SERVICE DIRECTIVE BULLETIN NO. 0108

Revision 1

DATE: September 14, 2009

1. SUBJECT: Cracked Pylons
2. MODEL: F-28F, 280F, and 280FX
3. EFFECTIVITY: All Serial Numbers
4. BACKGROUND:

Figure 1. Pylon (Viewed from Top)

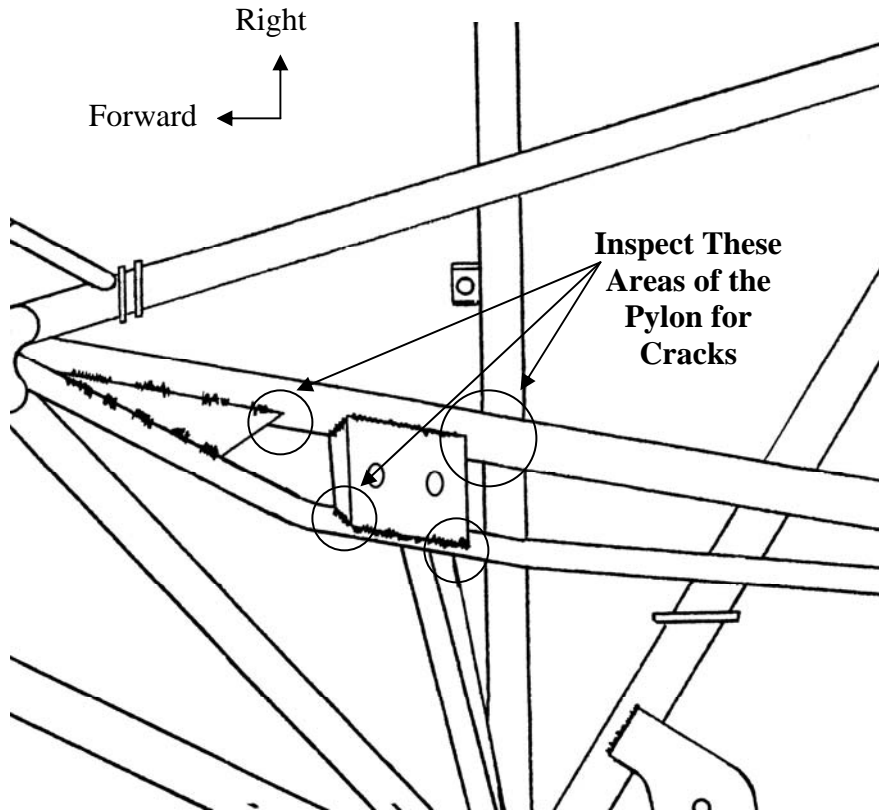
Enstrom recently received reports of 4 cracked pylons. The failures occurred in the area adjacent to the mounting bracket for the belt tension assembly bracket (Refer to Figures 1 and 2). Refer to Enstrom Service Information Letter SIL 0152 for additional information.

- A. Remove the cowling to gain access to the pylon in the area of the belt tension assembly.
- B. Using a 10-power glass, inspect the pylon area adjacent to the belt tensioning assembly mounting bracket and the gusset for cracks and other damage. (Refer to Figures 1 and 2).

- 1.) If no damage is found, continue to Step C.
 - 2.) If damage is found, contact Enstrom Customer Service for repair instructions and to report the aircraft serial number and time in service, and the serial number, part number, and manufacturer of the drive belt.

Figure 3. Flatness Inspection Criteria

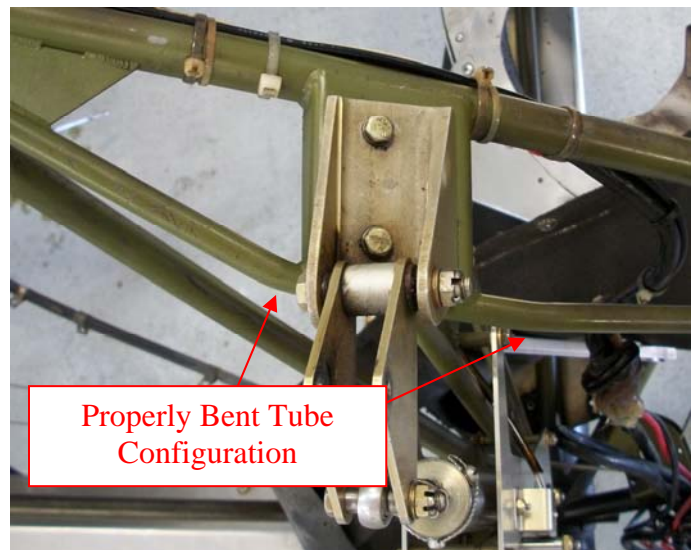
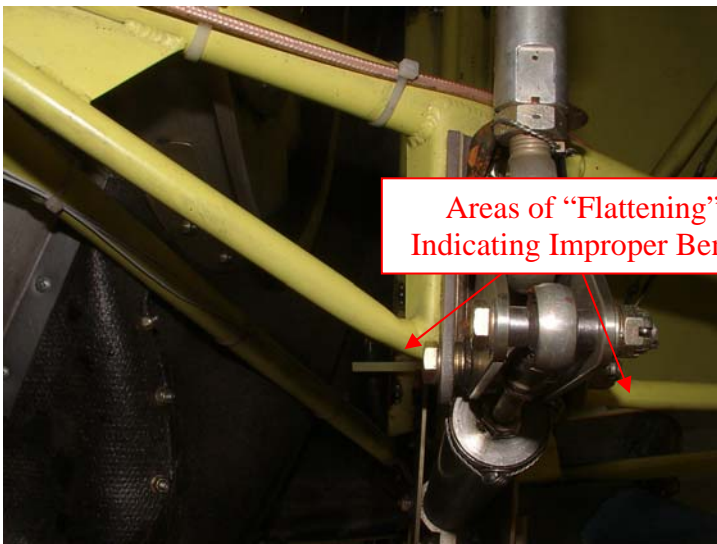
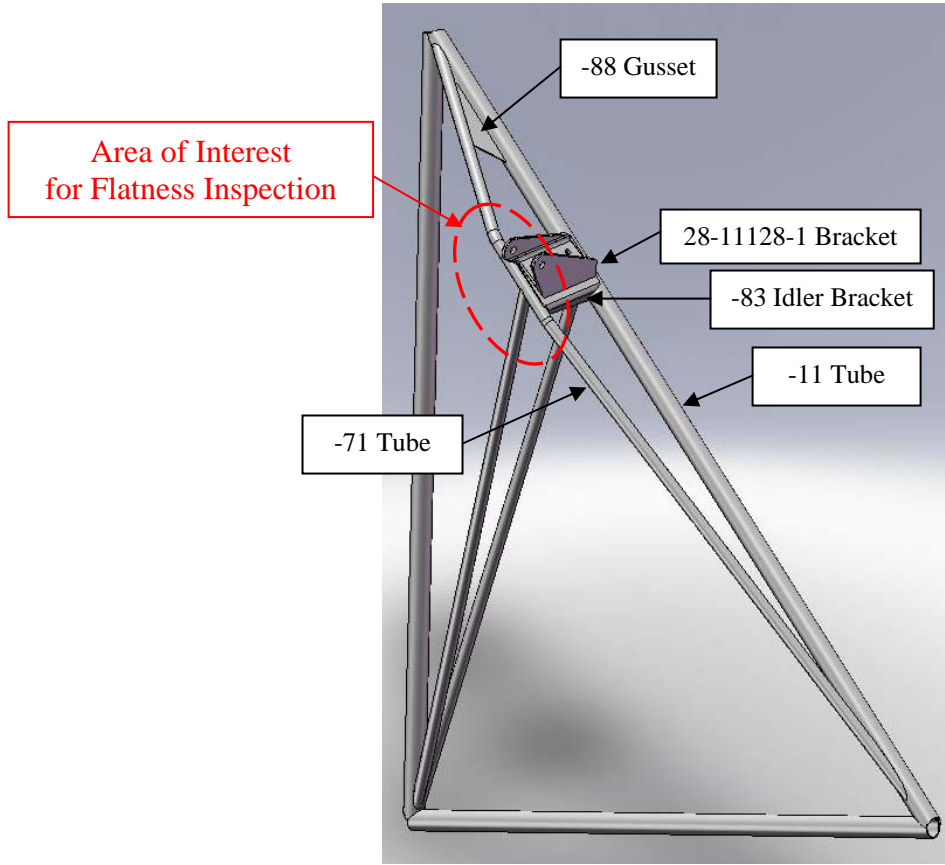
Enstrom has determined the cracked pylon tubes were assembled with improperly bent pylon tubes in two places. Figure 3 depicts improperly bent and properly bent tubes for reference. Flattening of the smaller tube is evident in both bends on the tube in the improperly bent configuration.

- C. Inspect the pylon tube in the area adjacent to the belt tensioning assembly mounting bracket for flattening in the bend (Refer to Figures 3 and 4).
